Office Action Summary	Application No. 10/534,576	Applicant(s) BELLOTT ET AL.	
	Examiner BRANDON M. ROSATI	Art Unit 3744

DETAILED ACTION

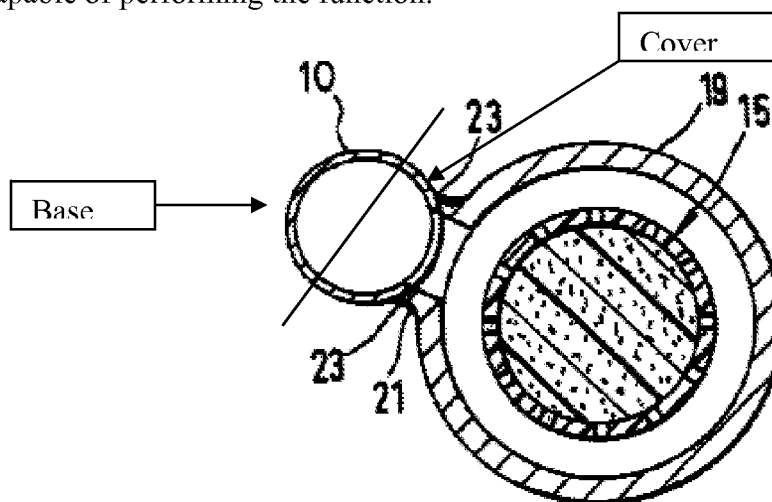
Regarding claim 1, Kaspar et al. disclose in Figure 1, a condenser comprising a block of tubes and ribs (i.e. block) (B), a collecting tube (10) having a base and a cover (See Figure Below), wherein the base is configured to accommodate the ends of the tubes, a collector (14) arranged in parallel to the collecting tube, fluidly connected to the collecting tube via openings (16 and 17), the collector comprises a tube (region above (19a)) and a profile piece (19) having connecting openings (16 and 17), wherein the profile piece has an integrally formed first over part which forms at least part of the cover (Column 2, Lines 29-60). It is noted that the phrase "for motor-vehicle air-conditioning units" is a statement of intended use and the device is capable of performing the function.

Regarding claim 2, Kaspar et al. disclose the cover connected to the base (see Figure above)

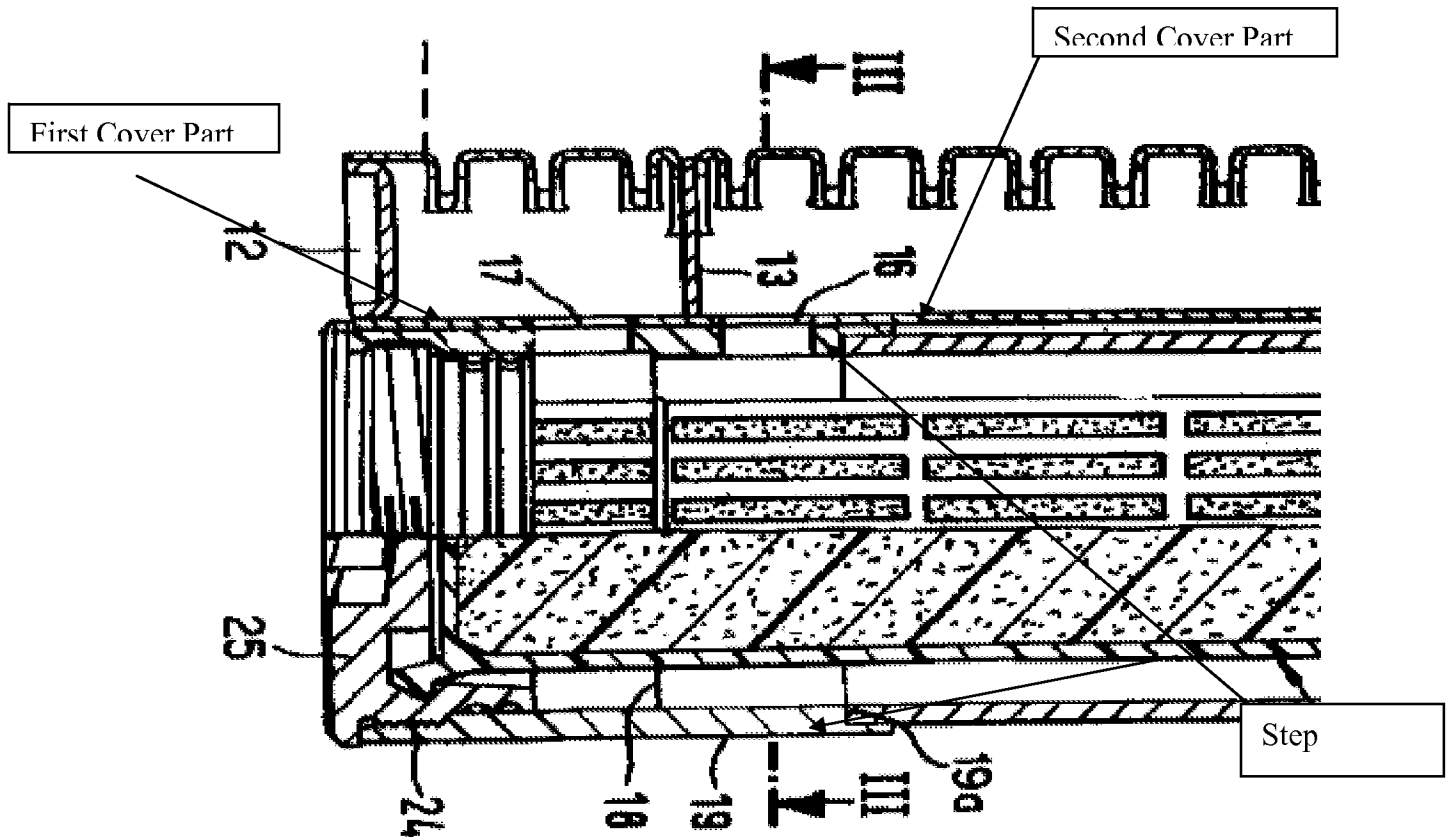
Regarding claim 3, Kaspar et al. disclose the cover of the collecting tube composed of the first cover part and a shortened second cover part (see Figure below)

Regarding claim 6, Kaspar et al. disclose the first cover part and the profile piece having a top edge which forms a step against which a second cover partially bears (see Figure above).

Regarding claim 10, Kaspar et al. disclose a second cover part (see Figure above) wherein the cover of the collecting tube is formed by at least the first cover part and the second cover part.
